**PLANNING DEPARTMENT SUPPLEMENTAL FINDINGS OF FACT**  
**AND CONCLUSIONS OF LAW**  
**File No.: SPAR-17002**

**Consideration of a Site Plan & Architectural Review application  
to construct a 245-unit multifamily development known as Smith Crossing at Twin Creeks**

<b>Applicant:</b>	)	Findings of Fact
PCMI, Inc.	)	and
353 Dalton Street	)	Conclusion of Law
Medford, OR 97501	)

Figure 2 – Master Plan Exhibit 3

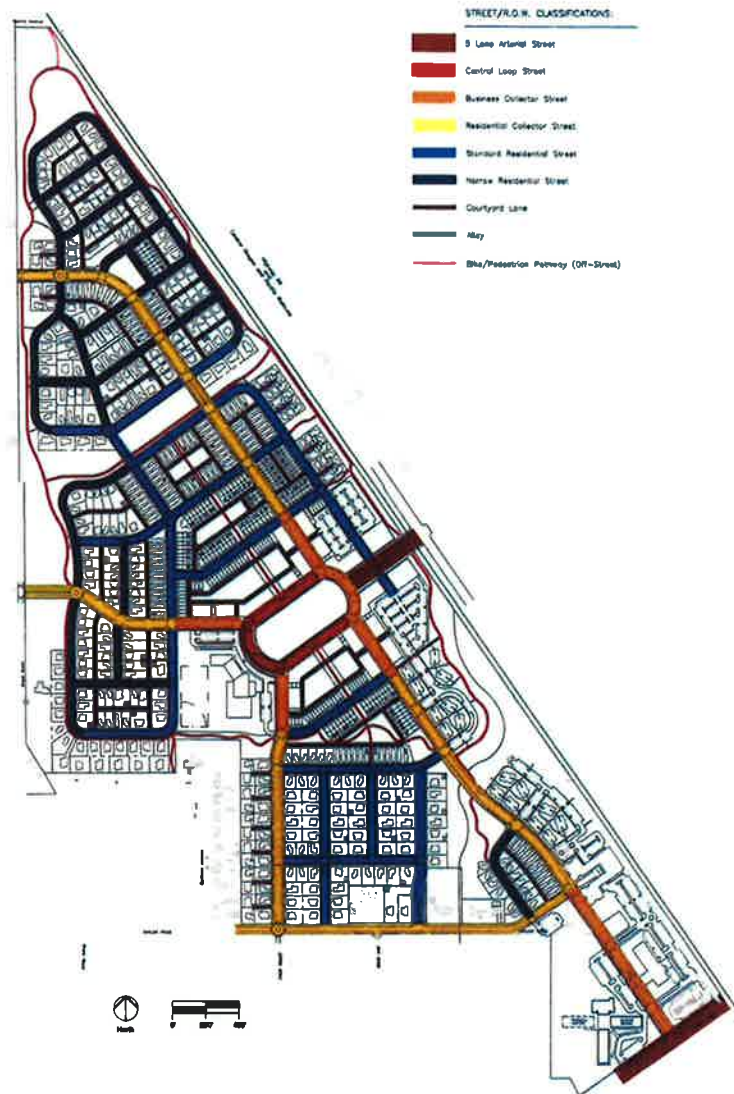
- 1) Streets. *Exhibit 3 (Figure 2) presents the required street network for Twin Creeks. Both Phase 1 and Phase 2 site have frontage on North Haskell Street, a Collector. North Haskell Street was constructed per Exhibit 3 as part of Twin Creeks Crossing Phase I and Pine Street Station in 2005-2006. The only outstanding improvement on North Haskell Street is the construction of frontage improvements (i.e. sidewalk and landscape row) for Phase 1. Per the Applicant's Site Plan (Figure 5), the site improvements are proposed consistent with the Master Plan.*

- 2) Off-Street Pedestrian Accessways. *An off-street pedestrian accessway is identified on Exhibit 3 (Figure 2) providing connectivity between North Haskell Street and Twin Creeks Crossing along the Griffin Creek open space corridor. As illustrated on the Applicant's Site Plan for Phase 1 (Figure 5), a Minor Pedestrian Accessway is proposed along the project site perimeter from North Haskell Street to the northeast property boundary. The proposed design complies with the Minor Pedestrian Off-Street Accessway Cross Section identified as Exhibit 12 in the Master Plan with the exception of a 65-ft section at the north east property corner. Since the Master Plan doesn't indicate whether the pedestrian accessway is to be located on the project site or the adjacent open space lot, there is an opportunity to relocate this portion of the pathway and provide the required cross section. As conditioned, the Project can comply with Master Plan Exhibits 3 and 12.*

- 3) Phase 1 Shared Access. *Exhibit 3 illustrates an internal connection via a private drive between Phase 1 and the adjoining properties to the north (Figure 3). The private connection illustrated appears to be for open access, but the Master Plan does not provide clear instruction relative to internal circulation. The Applicant's Site Plan (Exhibit 1) illustrates a private connection at the northeast property corner as required. However, since the property to the northeast (37S 2W 03CA Tax Lot 1500) is planned for Employment Commercial use the Applicant has requested the shared connection be for emergency vehicle use only. The Applicant's request is to eliminate potential safety conflicts between the multifamily community and off-site traffic generated by a future commercial use. The owner of the Tax Lot 1500 has provided a letter of support for this request. Based on the lack of clarity offered by the Master Plan and support offered by the affected property owner, the City agrees that the Master Plan allows for the access restriction to protect public safety from the conflicts between a potential high-impact commercial use and medium density multifamily housing.*

**Conclusion Master Plan Exhibit 3, Circulation:** Based on an evaluation of the site plan for both phases (Exhibits 1 and 2), the proposed Project complies with Exhibit 3, Circulation relative to streets, off-street pedestrian access (as conditioned) and shared access.

**Figure 3 – Master Plan Exhibit 18**

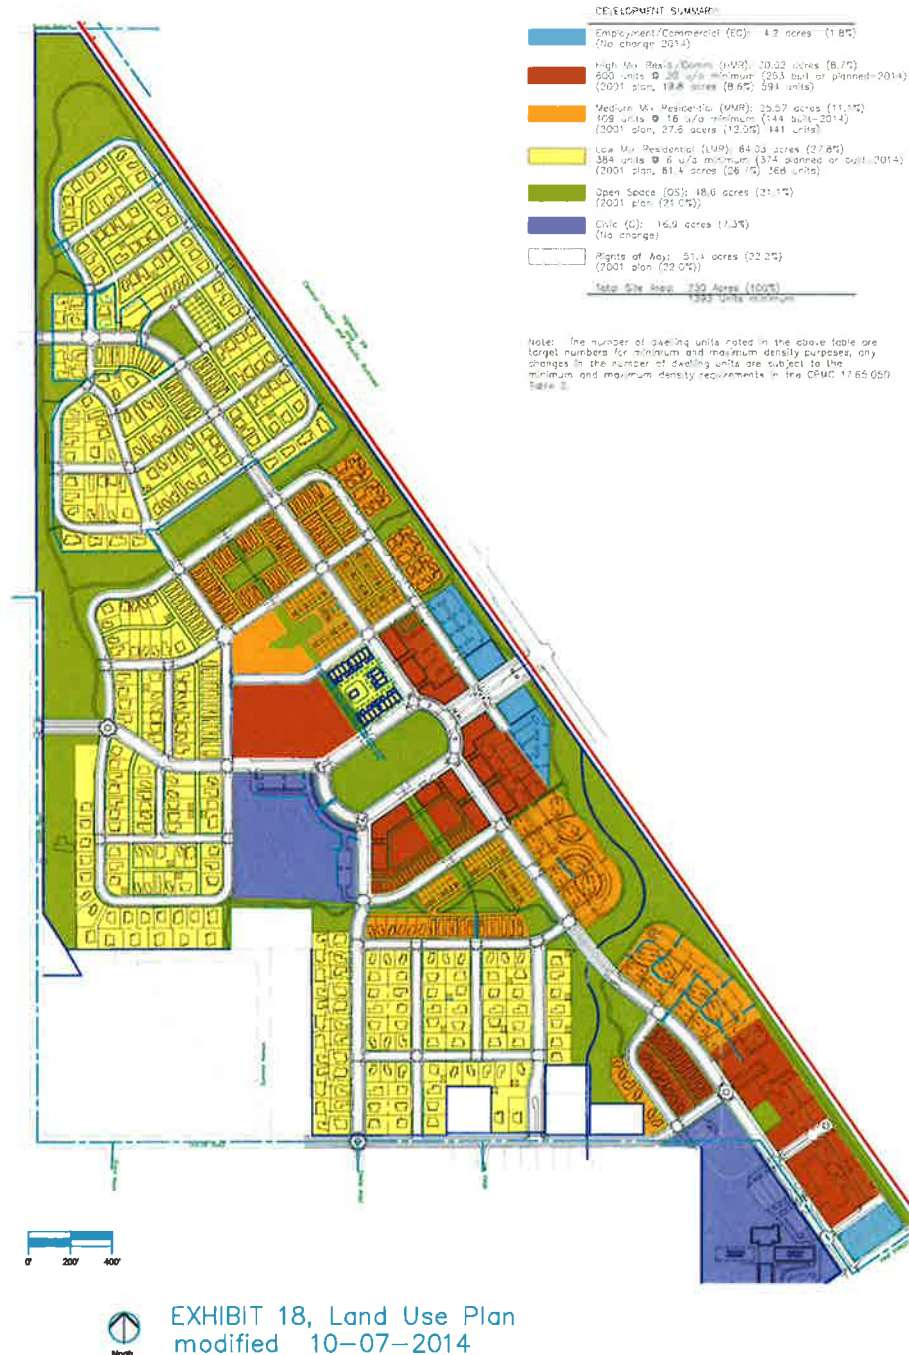
**Finding Land Use (Exhibit 18):** Per Master Plan Exhibit 18 and the City's Zoning Map, the Project Site is designated as Medium Mix Residential (MMR), which permits medium density multifamily housing. The Project is multifamily housing within the minimum/maximum range for density (See Finding 17.65.050(D)) as required by the Master Plan.

**Conclusion Land Use (Exhibit 18):** As evidenced above the proposed Project complies with the Twin Creeks Master Plan Exhibit 18.

**Figure 4 – Master Plan Exhibit 35**

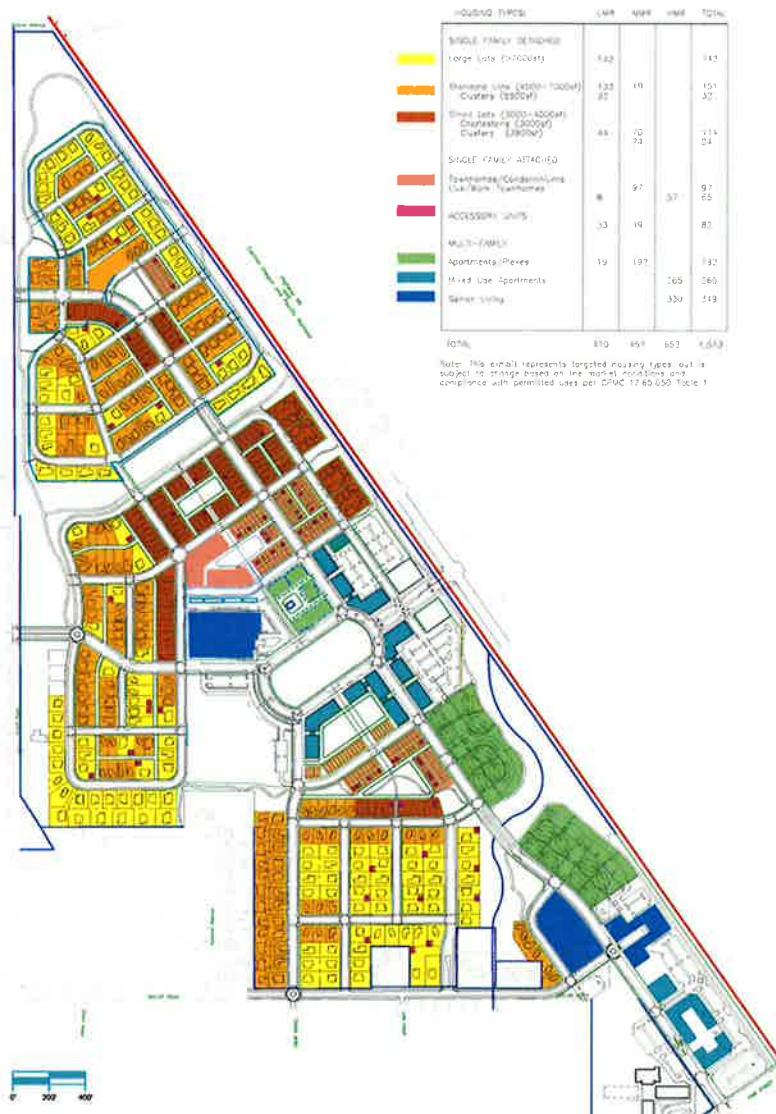
***Finding Housing Plan, Exhibit 35:*** The Site Plan for both Phases (Exhibits 1 and 2) illustrate the proposed multifamily housing project with eight (8) apartment buildings on Phase 1 and nine (9) apartment buildings on Phase 2. This layout proposes placement of buildings along the street frontage consistent with the maximum setback allowed in the MMR zone. Other buildings are clustered throughout the site to promote views of the adjacent open space area.

***Conclusion Housing Plan, Exhibit 35:*** As evidenced by the Site Plan for both Phases (Exhibit 1 and 2), the Project is consistent with the Twin Creeks Master Plan Housing Plan (Exhibit 35).
